# 802.3df D1.1

# Comment Resolution

P802.3df editorial team

Figure 173-3—32-8 PMA functional block diagram

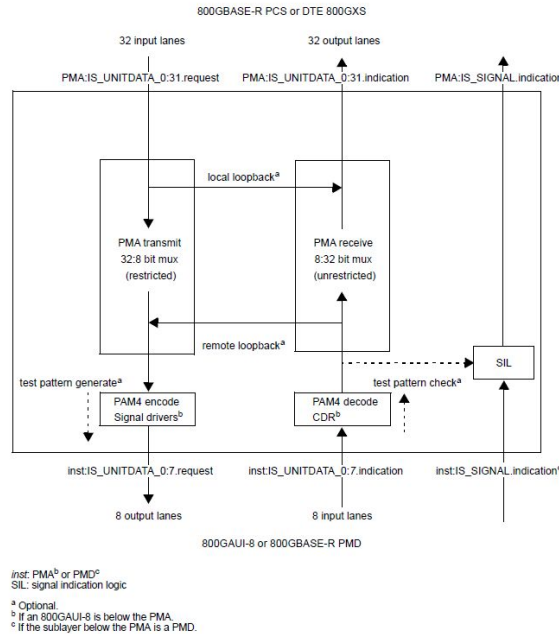
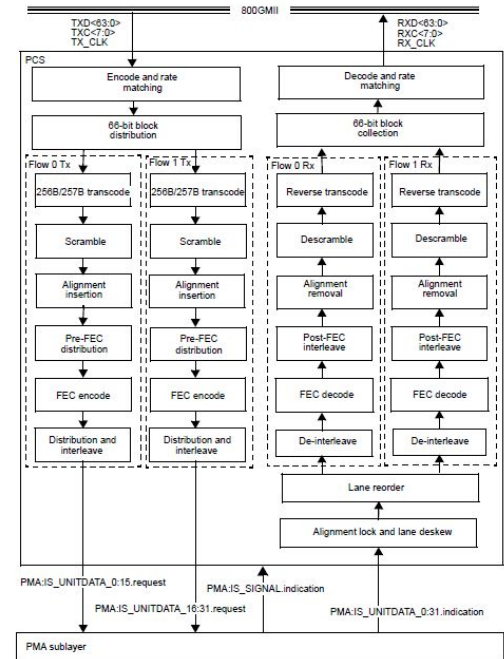
Cl 173 SC 173.4 P 217 L 6 # 87  
 Dawe, Piers Nvidia  
 Comment Type T Comment Status D (bucket1)

PMA:IS\_UNITDATA\_0:31.request would be better shown as PMA:IS\_UNITDATA\_0:15.request and PMA:IS\_UNITDATA\_16:31.request as in Figure 172-2. The PMA doesn't really know lane numbers, it doesn't read alignment markers, but it needs to know the two groups to apply the restricted bit muxing rules. The output lanes can stay as one group.

Show two groups of 16 input lanes, PMA:IS\_UNITDATA\_0:15.request and PMA:IS\_UNITDATA\_16:31.request. Similarly for the 32 PHY\_XS:IS\_UNITDATA\_0:31.indication lanes in Figure 173-4, 8:32 PMA functional block diagram.

#### PROPOSED REJECT.

There are 32 PCS lanes represented by PMA:IS\_UNITDATA\_0:31. Figure 172-2 shows the two groups, one from 0:15 and the other from 16:31, to show how the lanes from each flow map to the set of 32 PCS lanes. Showing the separation of the two groups of lanes in this PMA diagram is not helpful. Since the PMA is connected directly to the PCS (colocated), the lane numbers are known by the PMA.

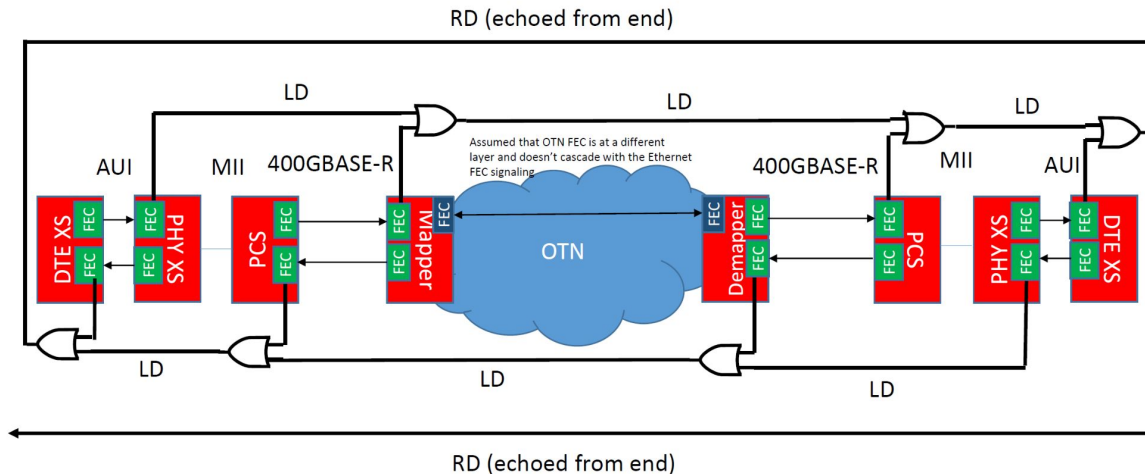
Cl 173 SC 173.1.3 P 213 L 10 # 85

In common cases (800GAUI-8) receive link status information may be used but isn't forwarded.

"Provide receive link status information in the receive direction": do we need another bullet, that when connected to a PHY XS, it provides link status information in the transmit (egress) direction?

PROPOSED REJECT.

The opening sentence in 173.1.3 states "The following is a summary of the principal functions implemented (when required) by the PMA in both the transmit and receive directions." The phrase "when required" implies that some of the functions listed are conditional upon the PMA type. The requirement for each of the functions listed is specified per PMA type in 173.4.
